Interactive comment on “A framework for assessing flood frequency based on climate projection information” by D. A. Raff et al.

Response to Individual Comments: Original Reviewer comments indicated by number. Responses to comments immediately follow.

Fig. 1. Supplemental Figure 1: Full Caption in Text

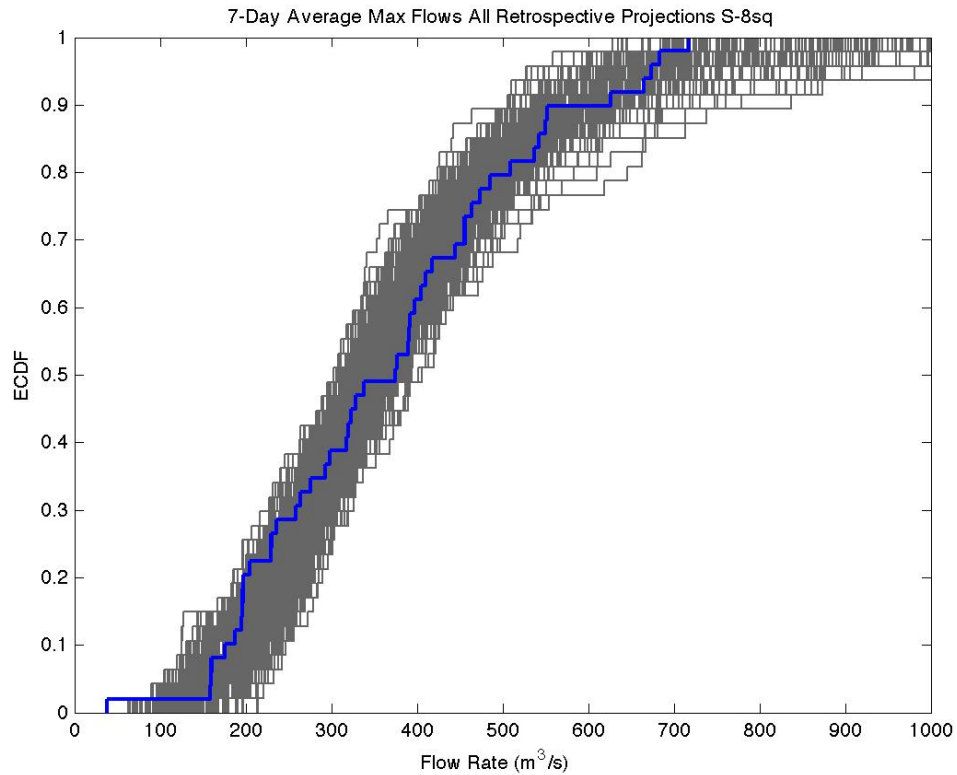
model. I see here the possibility that potentially important and presently unaccounted for model errors are being introduced in the authors analysis. This is because the precipitation and temperature data from which the forcings for the hydrology model are derived are themselves outputs from any one of several climate models. These climate models explicitly model physics at the land surface and are therefore associated with particular rainfall-runoff sequences. Moreover, the land surface parameterizations in these climate models are explicitly coupled to the atmosphere through latent heat flux that is soil moisture dependent. Correspondingly, the temperature and precipitation regimes that emerge from these climate models are associated with particular rainfall-runoff regimes that are a result of the particular representation of the physics in each climate model. The authors have treated the hydrological model used in this study as being independent of the parameterization schemes embedded within the climate models from which the hydrologic model forcings are derived and have not reported on any efforts to verify that the hydrologic model used for the flood frequency analysis yields runoff volumes that are consistent with the runoff volumes produced by the climate models.

(2) Moreover, because the temperature and precipitation outputs used to derive the forcings for the hydrological model are obtained from a range of climate models that together span a broad range of parameterization schemes, it is likely that there is a correspondingly broad range of rainfall-runoff regimes that emerges from these climate models. The authors have used calibrated parameters for the hydrologic model, which remain fixed throughout the analysis. Setting aside for a moment the debate as to whether the changes in terrestrial vegetation associate with climate change would alter the rainfall-runoff characteristics in a way that would require adjustment of the model parameters, it seems that the variation between the physics of the climate models alone, and the corresponding variation in rainfall-runoff regimes these physics impart would necessitate the explicit treatment of uncertainty in the parameters and/or structure of the hydrological model. An explicit treatment of the uncertainty in the hydrologic model would, in principle, ensure that the rainfall-runoff regimes simulated by the hydrological model in response to forcings derived from a suite of climate models spans the range in rainfall-runoff regimes associated with those climate models. I see this as being a potentially important inconsistency in the authors' framework that would be particularly important in areas where the coupling between precipitation and soil moisture are thought to be strong. I suggest that the authors include a little more justification for their choice to neglect potential disparities in physics between the climate and hydrological models throughout the flood frequency analysis, and a discussion of the potential magnitude (if known) of discrepancies between the rainfall-runoff partitioning of the climate versus hydrological models.

If it is a question about whether the algorithm presented in the manuscript is able to reproduce the antecedent period and calibration period of the Sacramento model it is shown (Figure 4) that peak values are well reproduced. Reviewer Flores identifies that

volumes may be an issue as well. Here please see Supplemental Figure 1 that show that, like the peaks, volumes are also well reproduced. This figure was not included in the initial manuscript over the concern with density of information and length of the document.

minor revision. As our previous response indicates, we can acknowledge this limitation in methodology and cite the body of literature that reiterates its applicability. Further, we would like to reiterate that the climate models are operating at a spatial scale that is inconsistent with the generation of flood flows. We have relied upon the climate models for representations of temperature and precipitation. We then rely upon a spatial downscaling methodology (Wood et al. 2002) as summarized in section 2.3 that includes a bias-correction schemes to enforce statistical consistency between the climate models results and observations during a common historical overlap period. Wood et al. 2004 and Salathe et al. 2007 have shown this bias-correction and downscaling technique to be a reasonable approach to get temperature and precipitation at a spatial scale necessary to evaluate hydrologic impacts, including basin-scale flood events as we have analyzed in this study. Figure 4 within the original manuscript as well as Supplemental Figure 1 further supports the ability of the methods.
